## SPI Working Group Contribution

Date: Nov 6, 1992

Source: John Goldie  
408-721-2075 (FAX 408-721-4785)  
Data Transmission Applications  
National Semiconductor

**Subject: Suggested changes to Figure 8 (Differential driver test circuit) for SCSI-3 SPI document**

**FIGURE 1 - Figure 8 from SCSI-3 SPI**

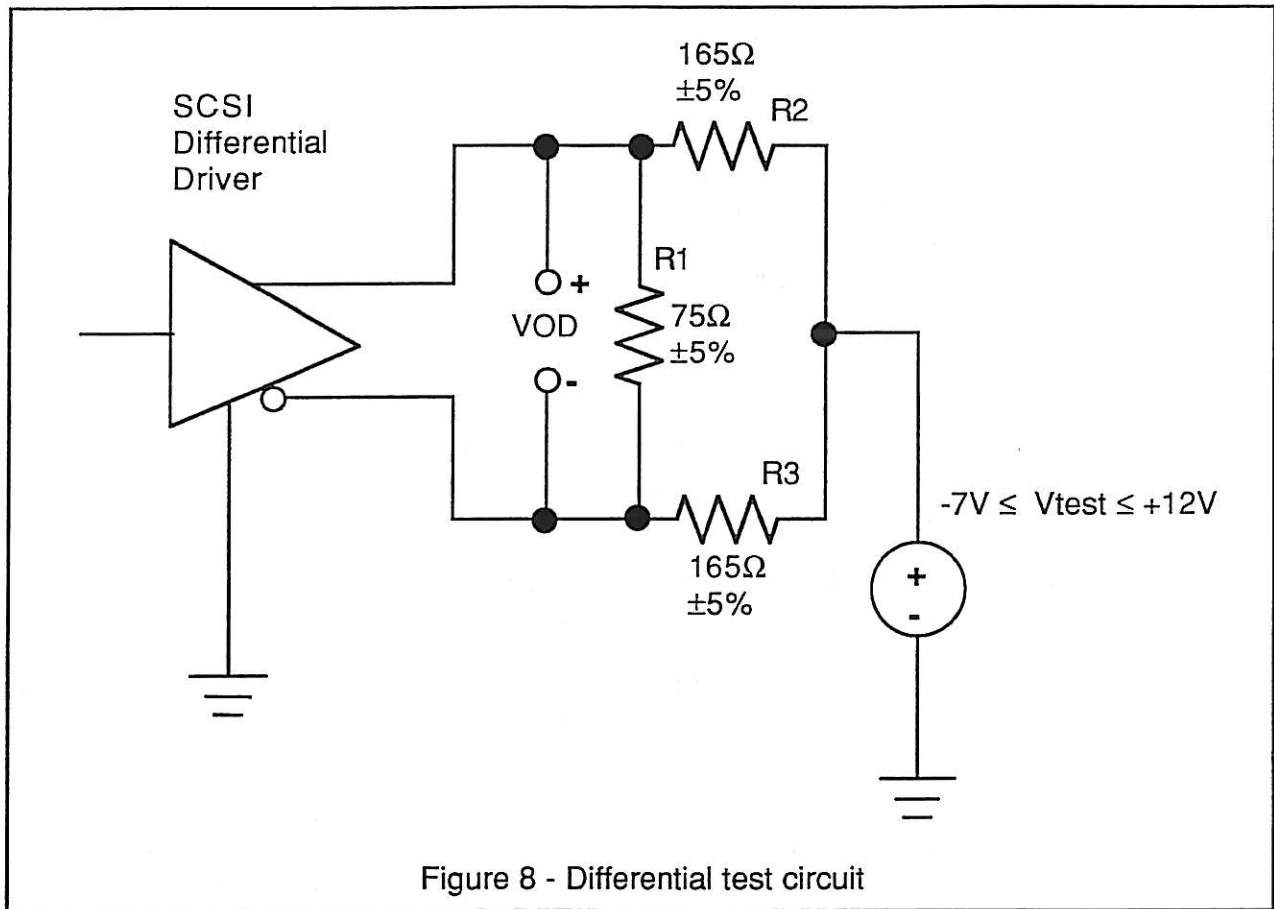
It is our concern that that the proposed differential test circuit shown in Figure 8 of X3T9.2/91-010R7 does not reflect a fully loaded SCSI-3 application. There are four points of interest that this test circuit fails to address:

1) It does not model the equivalent loading created by 32 loads connected in parallel. RS-485.1983 specifies that the input impedance of a unit load to be greater than 12k $\Omega$ . Thirty two units loads (allowed by SCSI-3 and RS-485) would present a 375 $\Omega$  load on each line. SCSI-1 and SCSI-2 could ignore this loading, since they limited the number of loads to 8 (12k $\Omega$  / 8 = 1.5k $\Omega$  worst case).

2) It does not model the fact that the 165 $\Omega$  resistors are pulled to a 5V potential difference. Figure 8 implies that they are pulled to the same potential, which is incorrect for the DC test.

3) A minor mistake of assigning the inverting driver output to the SCSI defined "-SIGNAL" lead. This is not the case for all applications. Some SCSI  $\mu$ C provide positive logic outputs while others provide negative logic outputs. The inverting driver output could be connected to the -SIGNAL or the +SIGNAL depending upon the SCSI  $\mu$ C.

4) It models a DC ground shift of -7V to +12V, which if actually occurred would most likely cause an overload in the system or cable fault since SCSI defines a common ground (and assigns 6 conductors to GROUND).

- does not model the input impedance of 32 loads ( $375\Omega$ ),
- does not model the Term Power potential of +5V,
- incorrectly assigns the non-inverting to the -SIGNAL lead, and
- assumes that a -7V to +12V DC ground shift can occur in a SCSI application.

Figure 4 - Loading seen by an RS-485 drivers in a SCSI-3 application

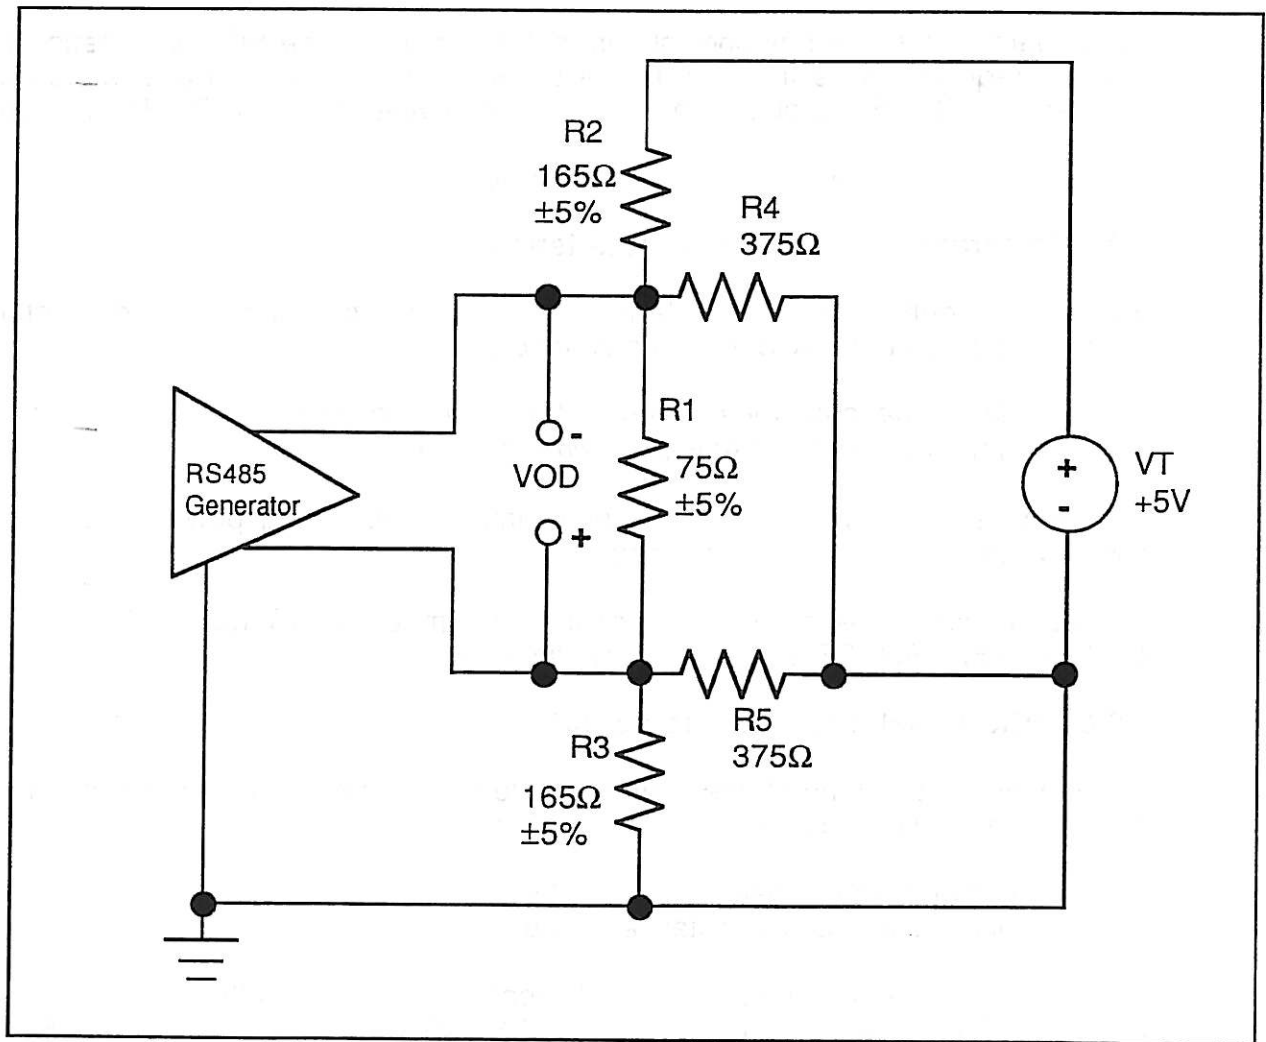
Based on figure 3, we recommend that the circuit shown in figure 4 be included in the SPI standard as the differential test circuit, in addition to compliance to RS-485 specifications. This figure models:

- The SCSI defined termination load (R1, R2, R3)
- The  $V_{term}$  potential of 5V ( $V_T$ )
- The worst case loading of 32 unit loads (R4, R5)

We recommend the following changes to sections:

### **7.2.2 Differential Output Characteristics**

Each signal sourced by a SCSI device shall have the following output characteristics when measured at the SCSI device's connector:

*a)  $V_{OD}$  (Differential output voltage) = 1.0V minimum for either steady state logic input. The test circuit for this parameter is shown in figure 8.*

All drivers shall maintain the high output impedance during power-up and power-down cycles until the driver is enabled.

The output characteristics shall additionally conform to EIA RS-485 1983.

*(INSERT NEW FIGURE 8, figure 4 of this document)*
